MEETING NOTES
Waste Management Area A-AX:
Data Quality Objectives Step 4, Define the Boundaries of the Study

MEETING DATE: September 1, 2020

This meeting was called to provide the agencies that participated in the WMA A-AX DQO process an opportunity to discuss Step 4 of the DQO process, Define the Boundaries of the Study.

Recommended WMA A-AX Soil Investigation Boundary

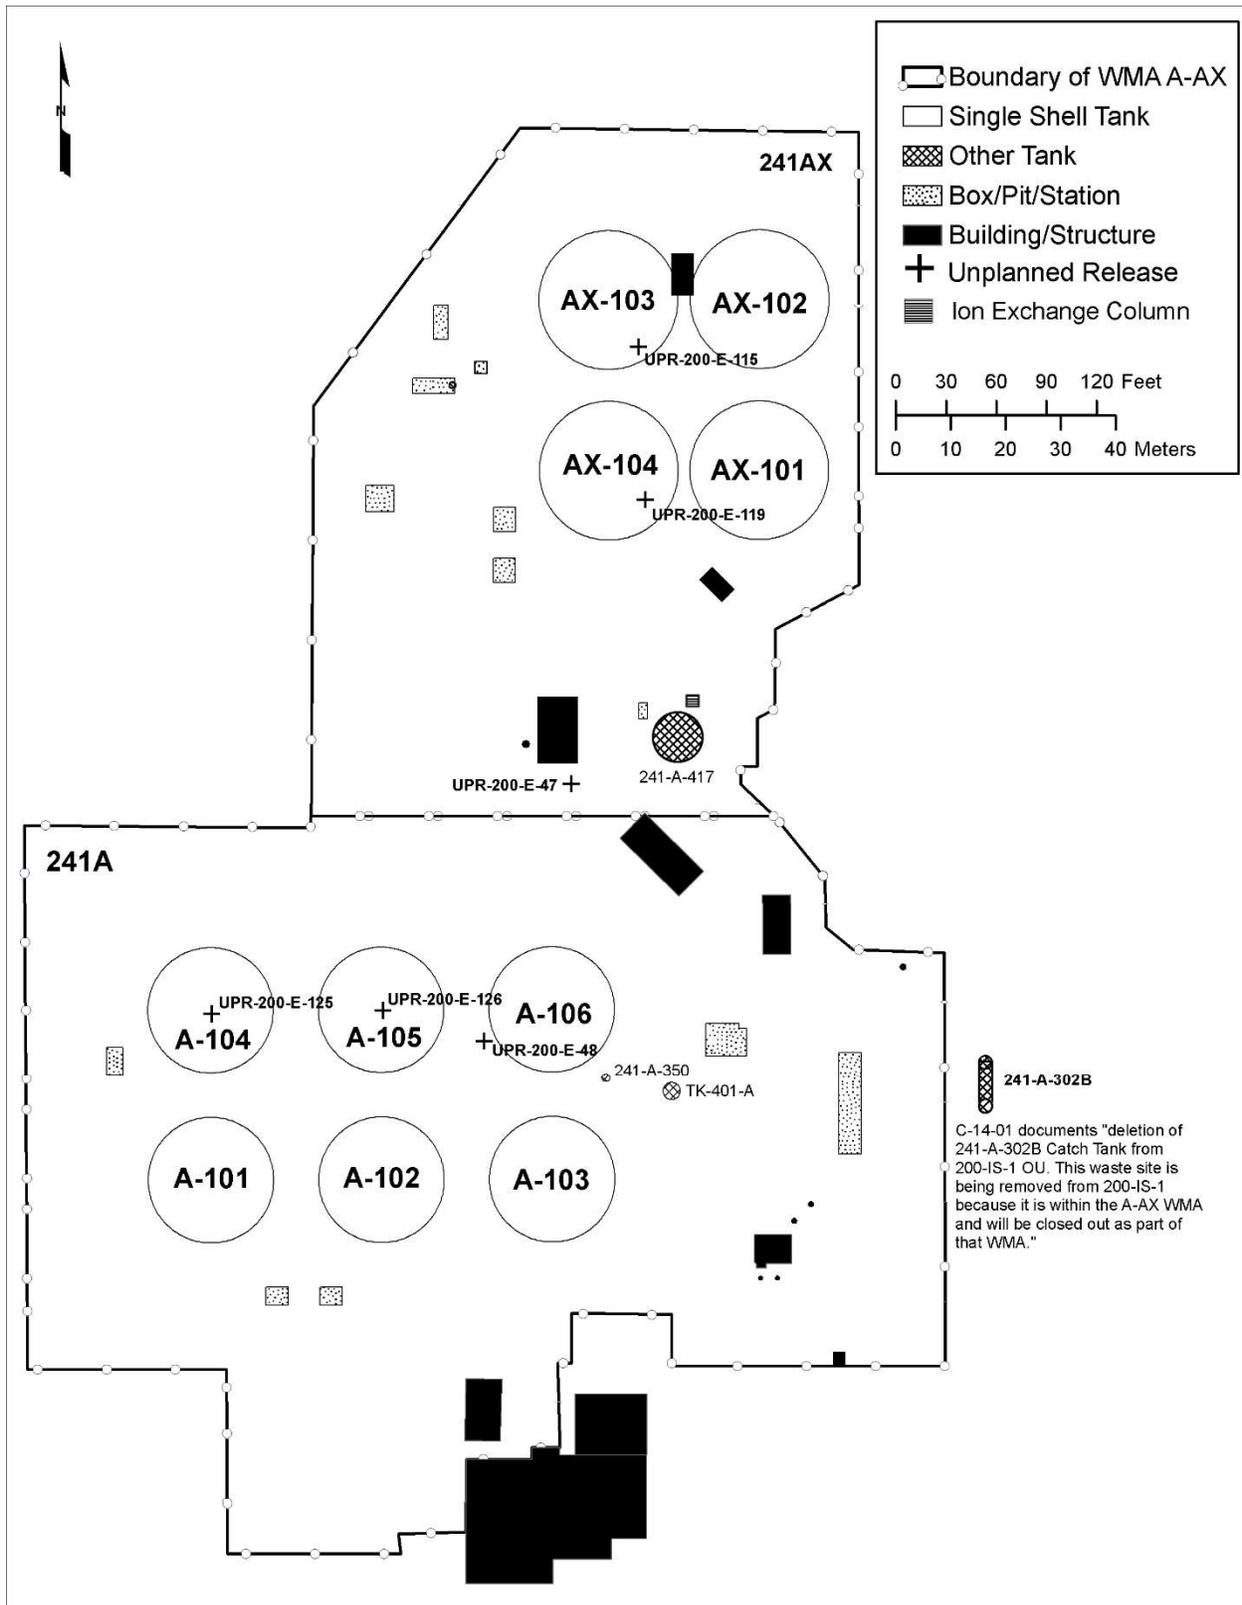
Ms. Tabor presented a graphic illustrating the recommended boundary for the WMA A-AX RFI soil sampling effort (Attachment 2). The recommended boundary matched that used in WA7890008967, DRAFT *Hanford Facility Resource Conservation and Recovery Act (RCRA) Permit Dangerous Waste Portion for the Treatment, Storage, and Disposal of Dangerous Waste*, Revision 9, for the 241-A and 241-AX Tank Farms (also known as A Farm and AX Farm). Ms. Tabor stated that the recommended boundary for the WMA A-AX RFI soil investigation also includes the soil at the 241-A-302B Catch Tank in recognition of *Hanford Federal Facility Agreement and Consent Order* (the Tri-Party Agreement, or TPA) Change Control Form C-14-01 (July 2014). This change control form deleted the 241-A-302B Catch Tank from the 200-IS-1 Operable Unit (OU) “because it is within the A-AX WMA and will be closed out as part of that WMA.”

Based on the reviewed information, Ms. Tabor recommended that the WMA A-AX RFI soil investigation boundary be defined as the area identified as the 241-A Tank Farm and the 241-AX Tank Farm in the Hanford Facility RCRA Permit plus the soil at the 241-A-302B Catch Tank.

**Boundary of Consolidated Waste Site 200-E-131
(2 pages)**

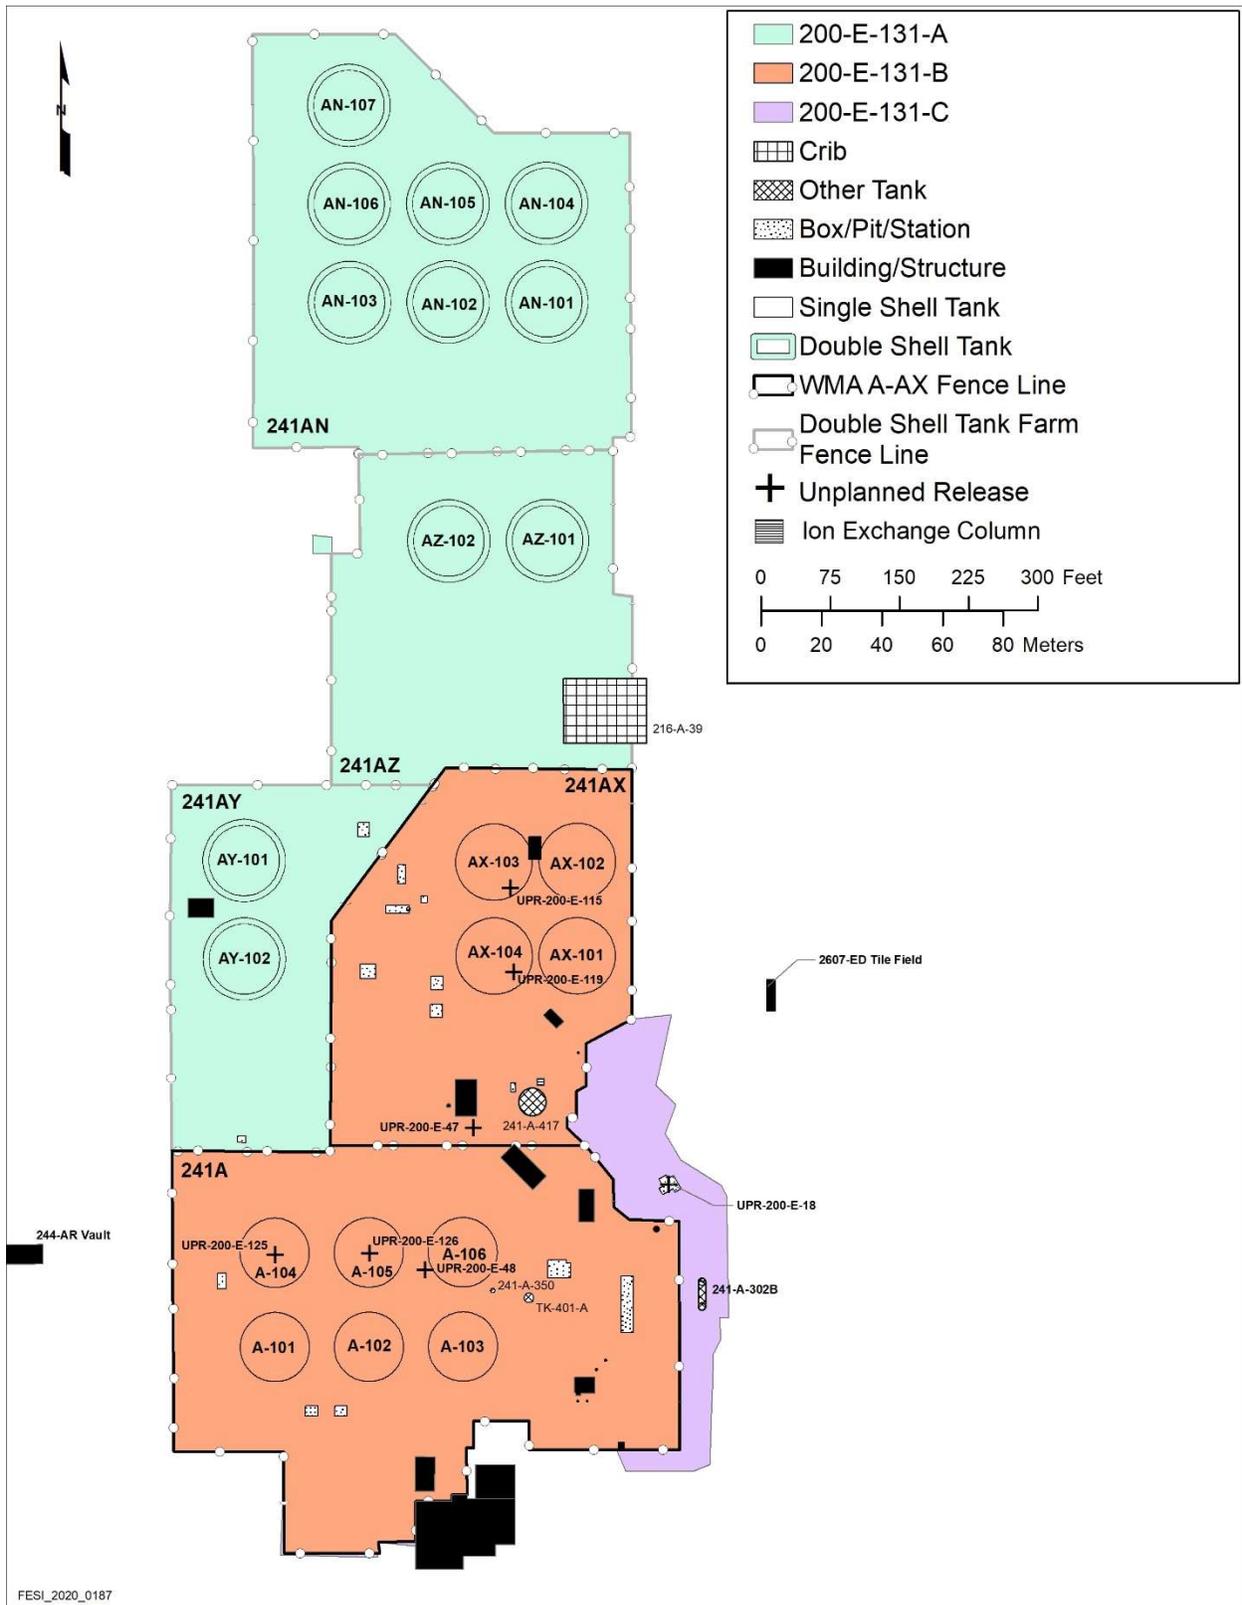
Ms. Tabor introduced the discussion about waste site 200-E-131, which is a contaminated soil waste site, and the 2607-ED Tile Field. Julie Robertson presented a graphic illustrating the boundary of 200-E-131 (Attachment 3). The graphic also illustrated the locations of the 2607-ED Tile Field and the 244-AR Vault. Ms. Tabor stated that waste site 200-E-131 is not in the TPA. She also stated that 200-E-131 and 2607-ED were assigned to WMA A-AX in WIDS, even though 200-E-131 encompasses double shell tank farms and areas outside the A Farm and AX Farm fencelines, and the 2607-ED Tile Field is well outside the east fenceline of the A Farms. Mr. Welsch noted that neither 200-E-131 nor 2607-ED are identified in TPA Appendix C as being assigned to any OU. Ms. Tabor stated that the portion of 200-E-131 shaded orange in Attachment 3 was the same area identified as 241-A Tank Farm and 241-AX Tank Farm in the Hanford Facility RCRA Permit, and she repeated the recommendation that the boundary of the WMA A-AX RFI soil investigation be identified as the soil within the A Farm and AX Farm fencelines and the 241-A-302B Catch Tank.

Ms. Robertson returned to the graphic (Attachment 3) illustrating waste site 200-E-131, which was created in 2001 to encompass all known soil contamination inside and adjacent to the 241-A, AN, AX, AY, and AZ Tank Farms (A Farms). Ms. Robertson noted the locations of the single and double shell tank farms within 200-E-131 and stated that waste site 200-E-131 was a consolidated soil contamination site encompassing six distinctly numbered unplanned releases that predated the acceptance (establishment) of 200-E-131, as well as several unnumbered spills and releases within and adjacent to the A Farms. Ms. Robertson stated that the written description of 200-E-131 also referred to the distinctly numbered unplanned release site UPR-200-E-18. This site was not consolidated into 200-E-131. This site is associated with a leak from a vent pipe at the 200-E-285 Sample Pit and is assigned to the 200-IS-1 OU per TPA Action Plan Appendix C.

Ms. Robertson stated that the graphic in Attachment 3 divides 200-E-131 into three segments because the soil investigations and cleanup decisions for the different segments will be determined through different pathways. The green segment will be addressed through documentation addressing the double shell tanks, the orange segment will be addressed in WMA A-AX documents, and the purple segment will be addressed predominantly by OUs. Ms. Robertson recommended that the agencies agree to segment 200-E-131 according to the decision document that will address each segment, and establish the WMA A-AX RFI soil sampling boundary as the area within the orange segment plus soil at the 241-A-302B Catch Tank.

The Ecology participants asked several questions seeking to understand why WMA A-AX should not address all three segments of 200-E-131. Ecology was particularly concerned about the proposal to

address the area outside the fenceline (shown in purple) separately from WMA A-AX. Mr. Welsch suggested transferring UPR-200-E-18 and 200-E-285 from the 200-IS-1 OU to WMA A-AX. Ms. Tabor noted that regardless of segmentation, all the contaminated soil in the area is the responsibility of DOE, and DOE's desire was to identify a logical and manageable approach to addressing all the locations. Mr. Hildebrand stated that numerous pipelines not shown in Attachment 3 are located in the purple segment and are assigned to the 200-IS-1 OU. Kim Schuyler presented a graphic showing the additional structures in the purple segment, including pipelines and trailers (Attachment 4).

Mr. Welsch asked whether DOE could define a part of the purple segment to be kept with WMA A-AX, noting that remediation of the 241-A-302B Catch Tank is likely to affect the area from the catch tank back to the A Farm fenceline. Ms. Tabor noted that there is no simple dividing line to use for establishing the WMA A-AX soil investigation boundary and that the agencies will have to come to an agreement. She stated that CHPRC is installing the PW-2 well near the 241-A-302B Catch Tank, and CHPRC is responsible for groundwater monitoring. Ms. Skorska asked if the well is a groundwater monitoring well, and Ms. Tabor answered that it is. Mr. Lyon asked if the data from soil samples taken during installation of the well would be included in the WMA A-AX RFI report, and Ms. Tabor said that they would.

Ms. Robertson referred to the graphic in Attachment 3 showing the locations of the 2607-ED Septic Tank just inside the southeast fenceline of the 241-AX Tank Farm and the associated tile field east of the farm and well outside the fenceline. Ms. Robertson noted that the 200-EA-1 OU encompasses numerous septic systems and recommended that the 2607-ED Tile Field be addressed by an OU instead of WMA A-AX. Nina Menard asked whether there is a pipeline from the tile field to the tank; Ms. Robertson stated that she did not know. Ms. Menard asked DOE whether it was proposing to address the 2607-ED Septic Tank with WMA A-AX and the 2607-ED Tile Field with an OU, and Mr. Hildebrand said, "Yes."

- 200-E-131-A = DST-related documentation (green area)
- 200-E-131-B = SST-related documentation (orange area)
- 200-E-131-C = OU-related documentation (purple area)
